**Ministerial Planning Referral: ID-2024-2  
140-160 Harbour Esplanade, Docklands**

7 May 2024

## PLANNING REPORT

<b>Application number:</b>	<b>ID-2024-2</b>
<b>DTP Application number:</b>	Amendment C438melb
<b>Applicant:</b>	Development Victoria and the Australian Football League c/- Urbis
<b>Owner:</b>	Development Victoria and the Australian Football League
<b>Architect:</b>	Grimshaw Architects (Master Plan only)
<b>Address:</b>	140-160 Harbour Esplanade, Docklands
<b>Proposal:</b>	Planning Scheme Amendment C438melb which seeks to facilitate the redevelopment of the western edge of the Stadium Precinct in Docklands via an Incorporated Document and application of a Specific Controls Overlay
<b>Cost of works:</b>	Not applicable
<b>Date received by City of Melbourne:</b>	7 February 2024
<b>Responsible officer:</b>	Xavier Livy
<b>Report Date:</b>	23 April 2024

Figure 15 – Location of the 3 pedestrian access points from Harbour Esplanade which has a minimum width of 12 metre (source: Applicant's Development Envelope Drawings associated with the Master Plan)

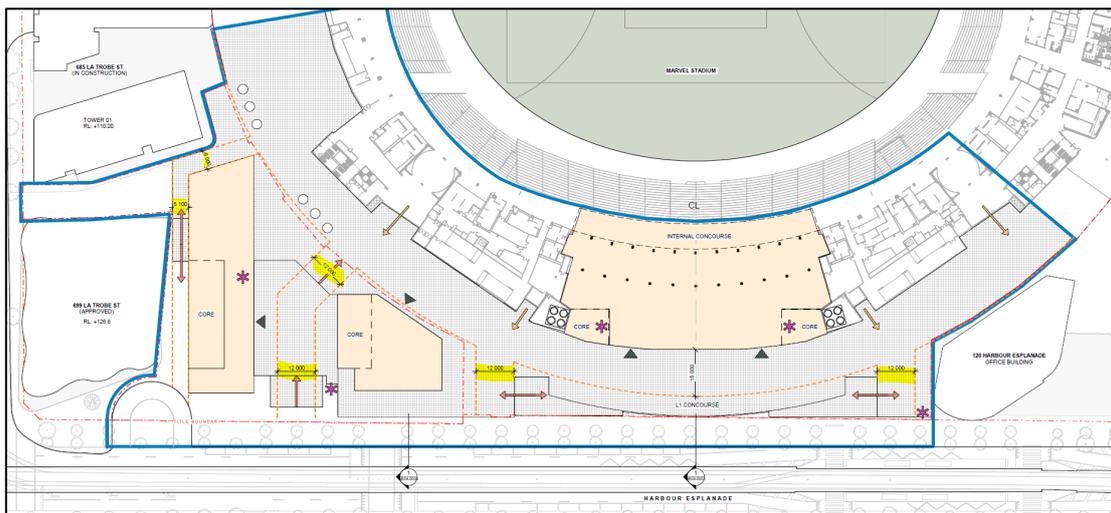
This outstanding matter forms as a recommendation to the Minister – refer recommendations 10.1.6 of this report.

Figure 16 – Master Plan consideration of flooding implication and how they can be addressed along Harbour Esplanade (source: Applicant's Master Plan)

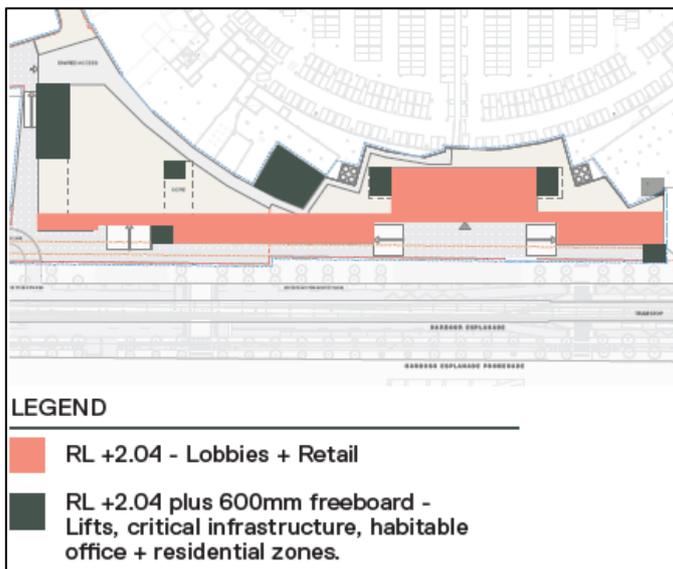
These flood mitigation concerns and matters form recommendations to the Minister – refer recommendations 10.1.7 of this report.

Figure 17 – Indicative cross section demonstration landscaping across the podium and concourse (source: Applicant's Master Plan)

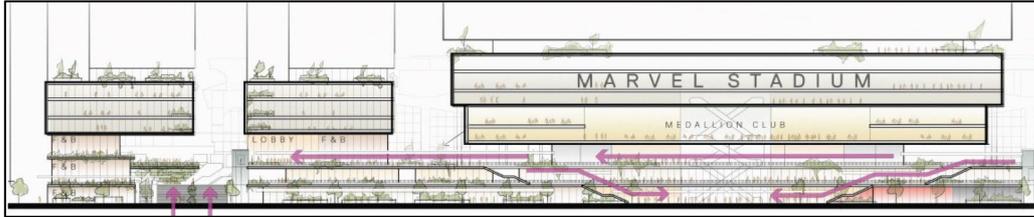
These outstanding landscaping matters form recommendations to the Minister – refer recommendations 10.1.8 of this report.

Figure 18 – Location of wind mitigation measurements which include a series of canopies and fencing along Harbour Esplanade (source: Applicant's Wind Tunnel Model Assessment)

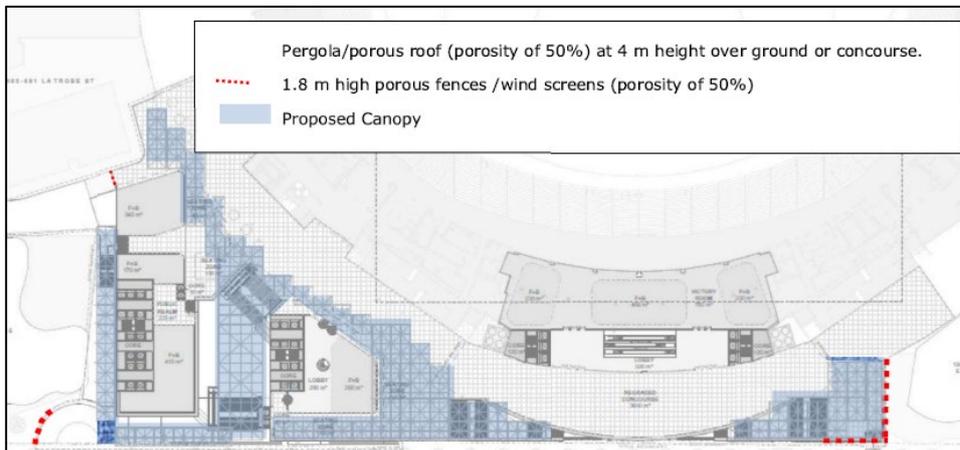
The proposed three tower envelopes have been tested through a wind tunnel model by Vipac Engineers and Scientists. Due to the strong wind impacts associated with the unique waterfront location, a series of recommendations are anticipated which include the need for canopies, pergolas / porous roofing, and porous fences / wind screens.

Subject to the inclusion of the recommended wind control measures, the proposal will be able to achieve the relevant safety and comfort criteria. However, a primary concern relates to the lack of detail on the design of these measures. The proposal requires significant canopy cover as well as 1.8 metre fencing in specific areas along Harbour Esplanade. The Master Plan should be explicit in ensuring the design and delivery of any wind mitigation measures do not compromise on any public realm principles which relate to open to the sky and transparent materials.

Figure 19– September 22<sup>nd</sup> Indicative shadow from 11-11:45am (top left to bottom right) (source: Applicant’s Master Plan)

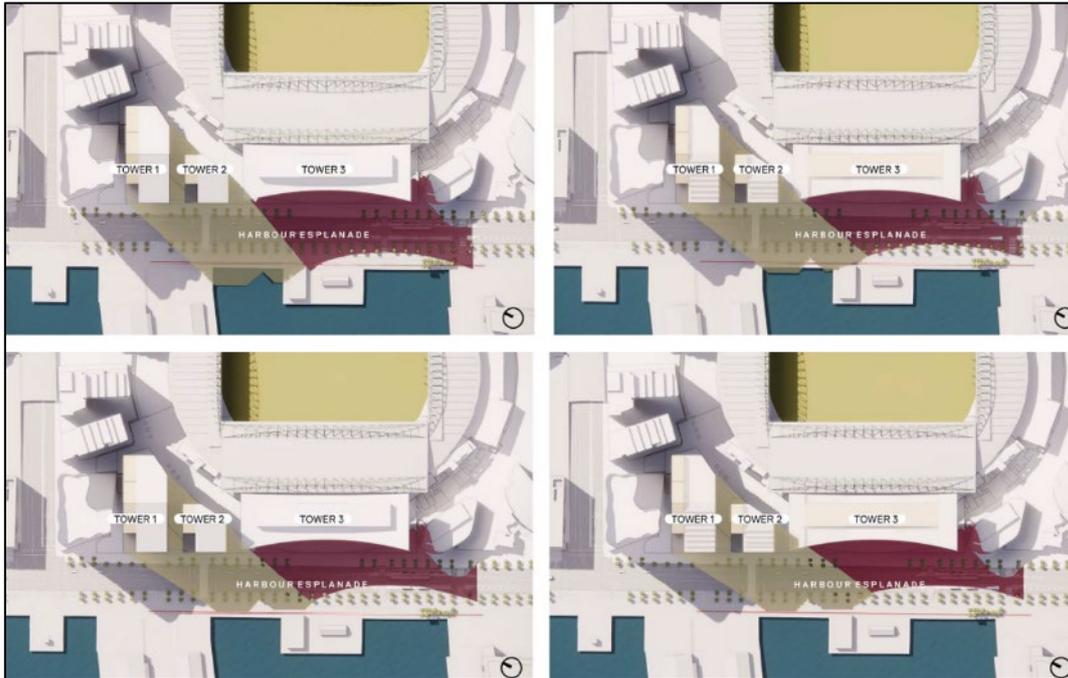
The primary impact to Harbour Esplanade is between 11am-12pm at the equinox to the western side of Harbour Esplanade. Due to the envelope height and setbacks, a continuous shadow mass extends across Harbour Esplanade during this time. When considering the existing conditions the impact could be considered minor as the shadow largely impacts the old tram lines and part of the western pedestrian footpath between 11am-11:30am at the equinox, however, it noted that in Harbour Esplanade Master Plan associated with TP-2014-1072 anticipates this space as a shared zone. The Application does not acknowledge the Harbour Esplanade Master Plan prepared by Development Victoria or any of the planned investment to the waterfront and Central Pier area. A comprehensive assessment of the potential shadow impact has not been considered as a part of the Master Plan and remains as a critical concern of the Application. The extent of shadow to this space could impact on its success, usability and the type of events within the shared zone.

Secondary to the above concern, the proposed envelopes result in additional shadow cast onto the Docklands Stadium field from 2.00pm onwards. The AFL (as owners of the stadium) have provided their consent to the extent of overshadowing.
